## Service description

Product: ST2440	Service description no: 4140-S001	Ver: 1
--------------------	---	-----------

Figure 2

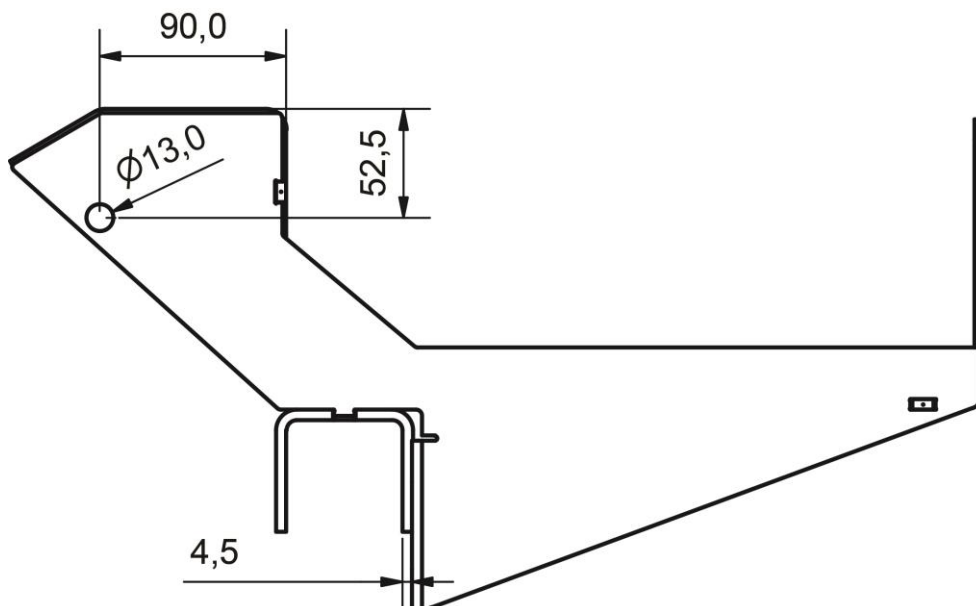
Screw holes on the bracket 14140021 and 14140022 do not fit against lap bank 14140033. (Figure 1)

1. Manufacturing defects on the racks produced between 30.08.2011 and 01.12.2011

1. Mark and drill a new hole  $\text{Ø}13$ . (Figure 2)
